SUBDIVISION REVIEW SHEET

CASE NO.: C8J-2020-0091.1A

SUBDIVISION NAME: Gregg Manor Subdivision, Phase 1 (Small Lot Subdivision)

**CITY OF AUSTIN – TRAVIS COUNTY – SINGLE SUBDIVISION OFFICE
SUBDIVISION APPLICATION – MASTER COMMENT REPORT**

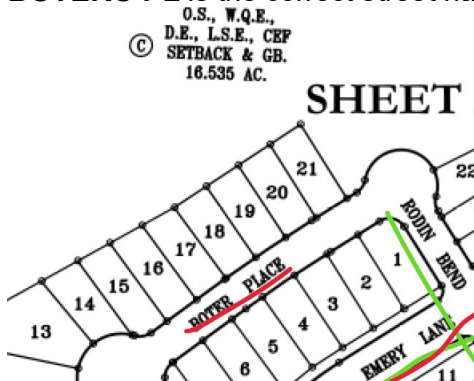
AD2: Please update label for **N SH 130** the directional N must be included in the location map

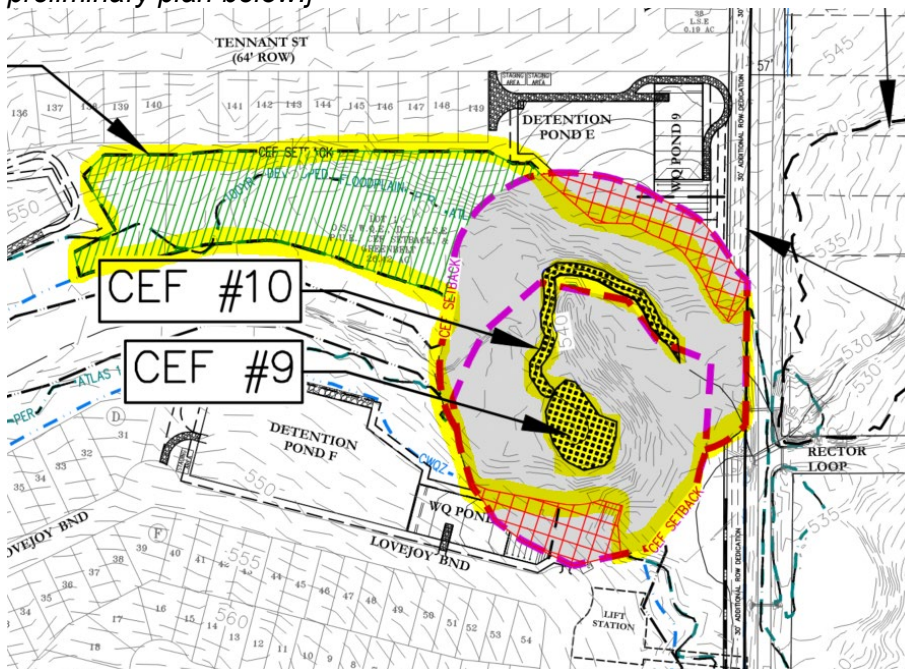
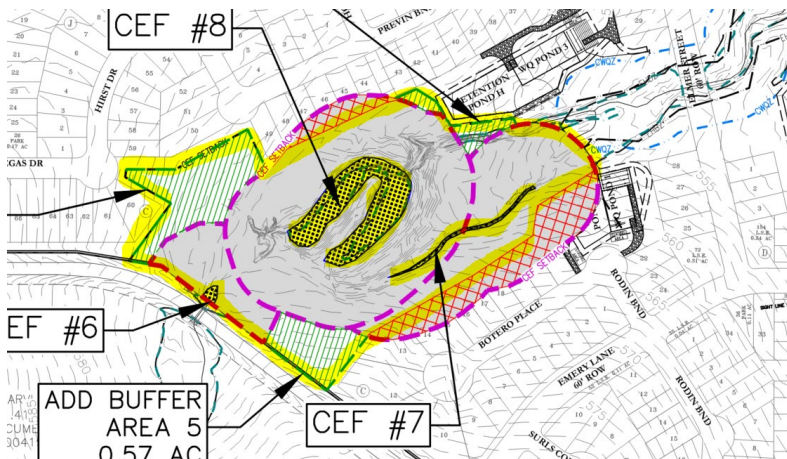
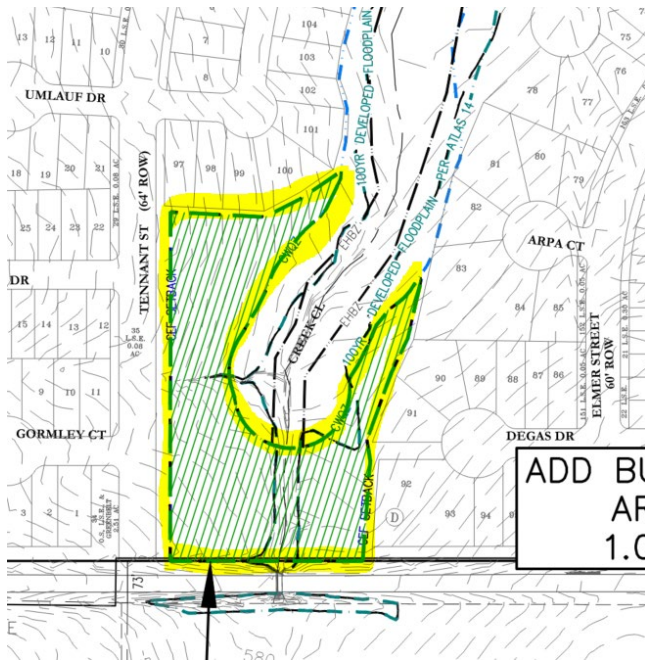
WB1. Update0. Please demonstrate compliance with LDC 25-8-281 or 30-5-281; LDC 25-8-282 or LDC 30-5-282.

Additional information: {This reviewer cannot establish wetland CEF protection provisions. e.g. Clearly show the boundary of the five wetland CEFs and clearly label the features: "WETLAND CEF" on all plat sheets where they exist. Please show the wetlands as shown on the CEF Mitigation Exhibit – Sheet 10 of the approved preliminary plan C8-2020-0091. See the wetland CEFs and modified CEF setbacks highlighted in yellow in the screenshot of the approved preliminary plan below.}

- WB2. Update0.** Demonstrate that this project complies with Critical Environmental Feature protection requirements and 1:1 mitigation for Critical Environmental Features. [LDC 25-8-281 or LDC 30-5-281; LDC 25-8-282 or LDC 30-5-282; ECM 1.10; ECM 1.10.4]
 Additional information: { This comment can be addressed, for example, by clearly showing and labeling “WETLAND CEF SETBACK” on all plan sheets where the CEFs and CEF setback are contained within the area shown. Please show the modified wetland CEF setbacks as shown on the CEF Mitigation Exhibit – Sheet 10 of the approved preliminary plan C8-2020-0091. See the wetland CEFs and modified CEF setbacks highlighted in yellow in the screenshot of the approved preliminary plan above in WB1.}
